**TOWN OF HUDSON**  
**PLANNING BOARD**  
**PUBLIC MEETING**  
**TOWN OF HUDSON, NH**  
**MARCH 25, 2015**

# Cobblestone Village Older Persons Housing Development Site Plan Review

## Staff Report

**PLAN UNDER REVIEW ENTITLED:** "Residential Site Plan Cobblestone Village 137 Belknap Rd, Map 184; Lot 27, Hudson, NH, prepared by Keach-Nordstrom Associates, Inc., dated: Jan. 23, 2015, latest revision date March 5, 2015, consisting of Sheets 1 - 28 and Notes 1 - 37 on Sheet 1 of 28 (plan attached hereto).

**SIGHT DISTANCE PLAN**  
SCALE: 1" = 40'

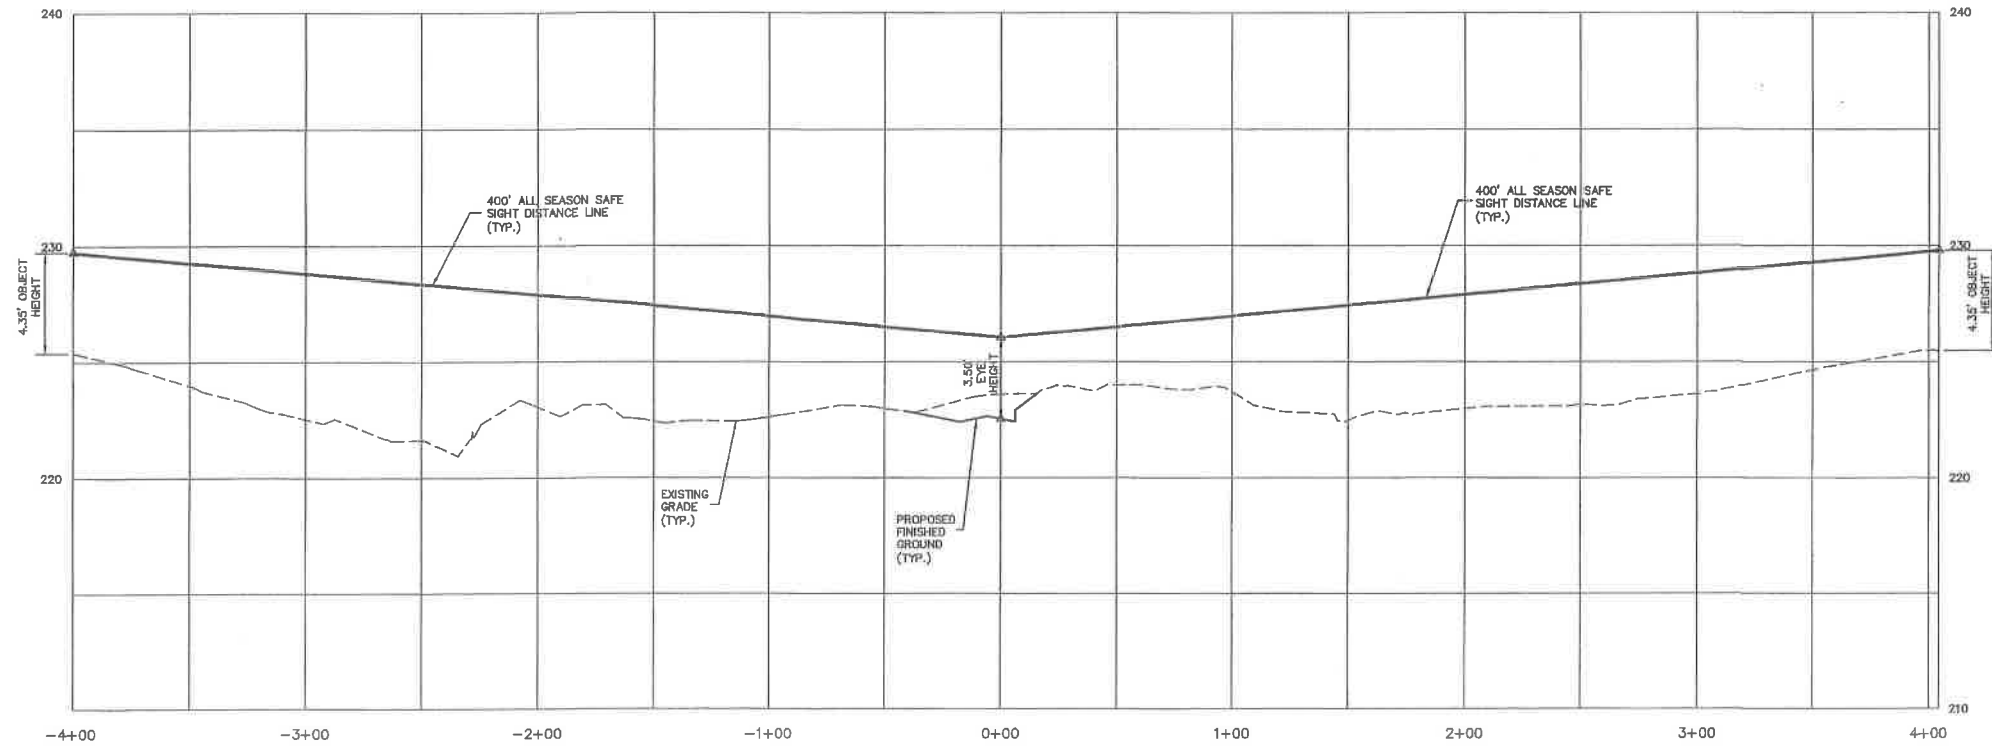
- the opposite side of Belknap Rd. within the ROW, looking west (see Sheet 20 of 28) .
- c) In addition to the CAP Fee of \$459.36, per unit (Note 21, Sheet 1), the Applicant is offering, per Note 24 on said Sheet, \$500, per unit, for offsite road improvements exclusive to Belknap St. NOTE: this is the same offsite road improvement, per unit, paid for by the Oak Ridge Older Persons Housing Development, which actually abuts the present site at the rear of both projects.

*The existing utility pole was added to sheet 20 to indicate there will be no visual impairment to sight distance.*

*The note on sheet 20 was revised to indicate not only brush to be trimmed, but also trees to be cut. In a conversation with Kevin Burns, the Road Agent for the Town, he confirmed the applicant's ability to cut several trees within the Belknap Road right-of-way. We will trim back only the necessary amount to achieve the required 400' of sight distance.*

*The existing utility pole was added to sheet 20 to indicate there will be no visual impairment to sight distance. However, the proposed stop bar was moved ahead by 3' to help sight distance around the pole. The stop bar was not moved further ahead because of sight distance around the curvature in the road.*

DATE: JANUARY 23, 2015 SCALE: AS SHOWN  
PROJECT NO: 14-0721-1 SHEET 22 OF 28

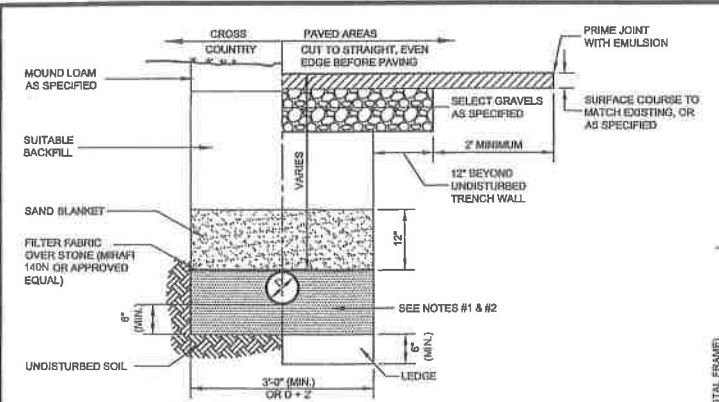
- d. *Former CLD Comment: The applicant should coordinate the Outlet Devices from Pond 18P: Wet Pond-1 within the AoT Application with the Outlet Structure Detail on Sheet 22 of the plan set.*

- d. The applicant should coordinate the Outlet Devices from Pond 18P: Wet Pond-1 within the AoT Application with the Outlet Structure Detail on Sheet 22 of the plan set.

Current CLD Comment: The applicant has provided a typical driveway detail and cross section on sheet 22. No further CLD comment.

*A typical driveway detail has been provided on sheet 22.*
